# Access Compliance Report

### (Curb Ramps)

Intersection ID: 29984	Main Street: CORBETT_SQUARE_LN	Cross Street: OLD_CAROLINA_DR	Location: SE
ADA ID: 0AE50C6597E1	Ramp Type: PerpDiag	Initial Pass/Fail: Fail	Overall Compliance: No
Codes/Mitigation Info/Possible Solution		Field Measurements/Component Compliance	
Severity Score: 46.25

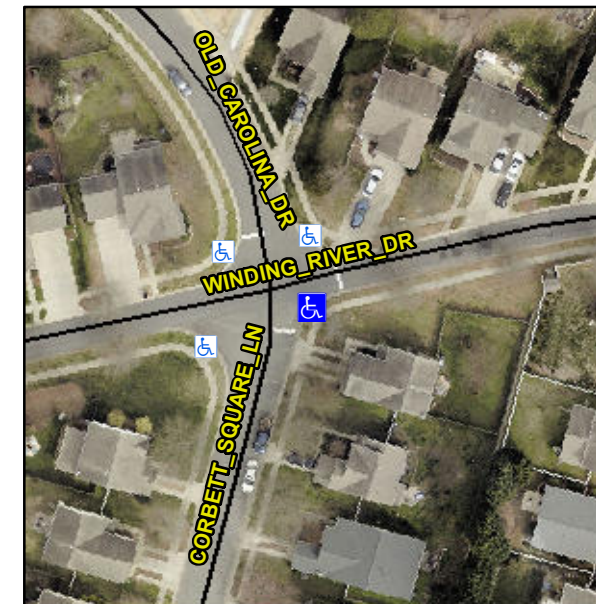
**Not Found, R304.5.1, R304.2.2, R304.5.3**

Compliance	Description	Data	Compliance	Description	Data
N/A	Ramp Length (in)	46.0	No	Ramp Slope (%)	11.7
No	Ramp Width (in)	47.0	No	Ramp XSlope (%)	10.2
N/A	Flare Type LT	N/A	N/A	Flare Type RT	N/A
N/A	Flare Slope LT (%)	N/A	N/A	Flare Slope RT (%)	N/A
N/A	Flare Traversable LT?	N/A	N/A	Flare Traversable RT?	N/A
N/A	Landing Length (in)	N/A	N/A	DWS Provided?	N/A
N/A	Landing Width (in)	N/A	N/A	DWS Contrast?	N/A
N/A	Landing Slope (%)	N/A	N/A	DWS Length (in)	N/A
N/A	Landing X Slope (%)	N/A	N/A	DWS Full Width?	N/A
N/A	Landing Curb? (Y/N)	N/A	N/A	DWS Offset (in)	N/A
N/A	Shared Landing?	N/A			
N/A	Gutter Ponding?	N/A	N/A	Gutter Slope (%)	N/A
N/A	Gutter Lip Ht (in)	N/A	N/A	Gutter X Slope (%)	N/A
N/A	Painted X Walk1?	No	N/A	Painted X Walk2?	No
	X Walk 1 Direction	To N		X Walk 2 Direction	To W
N/A	X Walk 1 Width (in)	N/A	N/A	X Walk 2 Width (in)	N/A
	X Walk 1 Slope (%)	2.9		X Walk 2 Slope (%)	8.0
	X Walk 1 X Slope (%)	6.0		X Walk 2 X Slope (%)	0.9

**Remove & Replace Curb Ramp With Two New Directional Ramps or Equivalent.**
